From: Anna Tidey
Sent: 22 January 2025 14:54:03 UTC+00:00
To: "su.local.development@westsussex.gov.uk"
<su.local.development@westsussex.gov.uk>
Subject: FW: FW: WSCC H/ways Response To Application Number DM/25/0061 at Barn Cottage Pavilion, HH
Attachments: 102 Existing Site Levels Plan.pdf

CONDITION 7 – CONSTRUCTION ENVIRONMENTAL MANAGEMENT PLAN (CEMP) CONDITION 10 – SITE SET UP

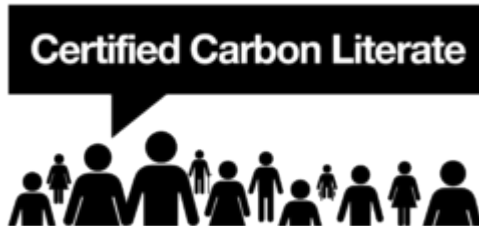
1. The CEMP states no parking on site yet the site set-up plan shows access in to site and parking on site. please clarify this point. The LHA question ability to provide suitable vehicle access in to site and provide space for parking and turning but the plan is not to scale so unable to check this.

2. Site set up plan shows temporary contractors buildings and storage areas.
3. Off-loading area shown on-carriageway, this may require some form of temporary licence from Highways Area Office to enable offloading on carriageway and ensure free-flow of traffic on Barn Cottage Lane.

I have received the attached response from Katie Kurek from WSCC Highways regarding the discharge of Conditions 7 and 10 of DM/24/1802.
Please note her comments 1 and 3 re: the site set up.

Site plan confirms there is access to site for contractors car parking and materials movements from offloading area only. Deliveries to site to be unloaded on Barn Cottage Lane.

The off loading area shown on carriageway is to prevent delivery vehicles from needing to reverse from/ onto site to ensure no reversing is required for site deliveries. See map extract pasted below, delivery vehicles can turn via Barn Cottage Lane, Hanbury Lane & America Lane.

The site set up plan has been scaled onto existing site levels plan and attached. The plan shows space for contractor workforce parking only in cars and vans.
